Planning Case #: Design Study 24265

Project Description: Approval of this Design Study (DS 24265) authorized the after-the-fact approval for amendments to previously approved design study (DS 23-201) for alterations at an existing historic single-family residence with an active building permit (BP 240042) located on Casanova 2 SW of 2nd in the Single Family Residential (R-1) District. Modifications approved under this Design Study include: 1. Enlargement of one kitchen window opening on the rear (west) elevation; and 2. Removal the exterior wall cladding and in-kind replacement to waterproof the building properly. Alterations not expressly listed in this authorization are not permitted. The project shall be constructed consistent with the plans application materials dated approved by Community Planning & Building Department on January 21, 2025 and the Phase II Historic Evaluation dated January 13, 2025 prepared by PAST Consultants, unless modified by the conditions of approval.

Planning / Building Department Update Application August 26, 2024

Re: Historic Assessment Addendum, Lincoln St. 4 NW of Santa Lucia Ave., Carmel, CA APN 010-173-006; DS 24-265 (Vais); BP 240042

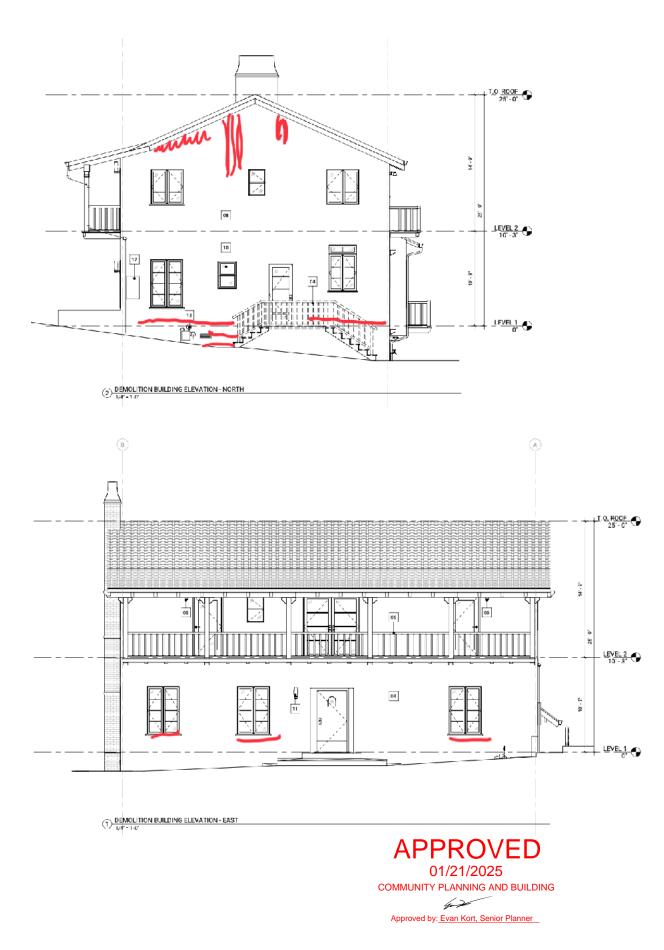
The following diagrams show all the areas where water damage is likely to have occurred, based on stains visible from the interior. Virtually any non-window aperture through the wall has failed, and many of the steel windows as well. Photos show details of the uncovered damage areas, and some of the likely problem areas where substantial water damage is visible inside.

We are proposing that we be permitted to remove as much stucco and underlying shear wall necessary to discover and repair all dry rot. On advice from professional plasterers, we believe the best approach is to replace all the stucco on any wall versus trying to patch on a per window/aperture basis.

Modification 2: West facing kitchen window expansion

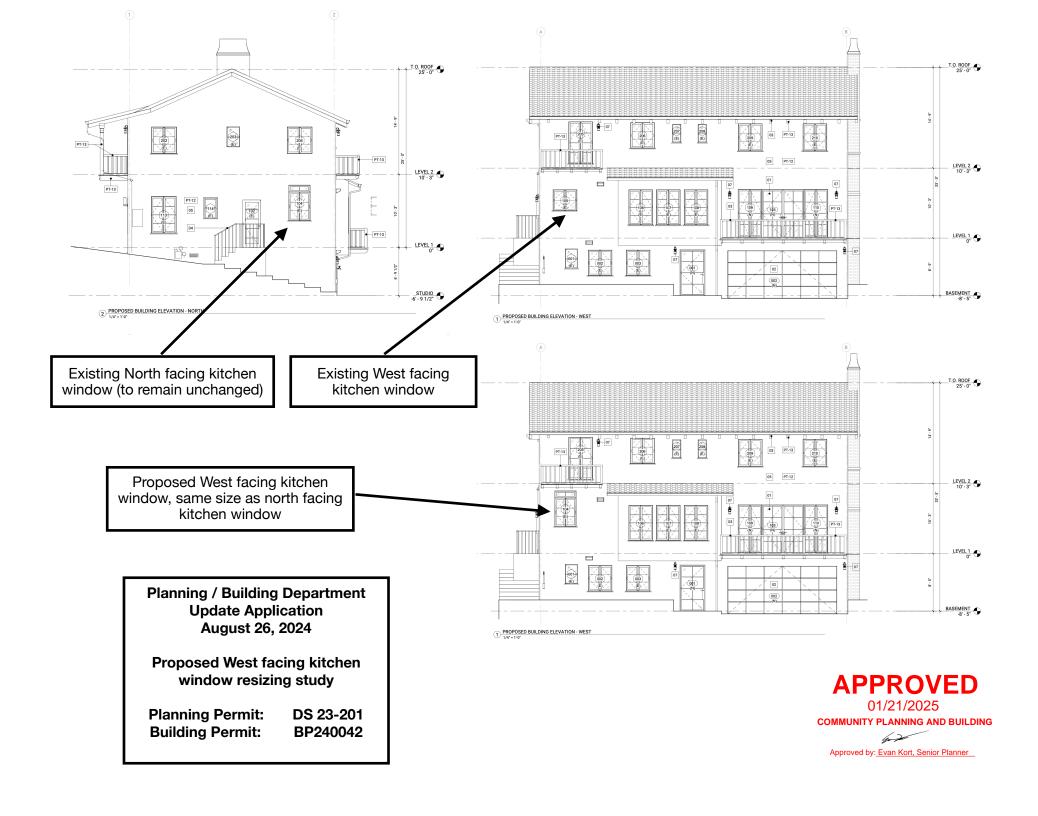
After removing the kitchen cabinets and shelves, it became apparent that the kitchen would benefit from having the corner windows be the same dimensions. The north wall window (on the right) is and will remain original. The shorter window is on the west facing wall and not visible from the street. We have been permitted to modify windows on that facade. We would like to expand that window to match the dimensions of the north wall window.

The only proposed exterior alteration shown on the August 26, 2024 design addendum is the enlargement of a rear (west) elevation kitchen window opening to match the window openings on the north elevation's kitchen wall. A metal window is being manufactured to match the style and material of the historic windows. Since this proposed design change is on the rear of the building

and the proposed window replacement will be the same design, style and material of as the historic windows, this treatment is appropriate according to this *Standards*.
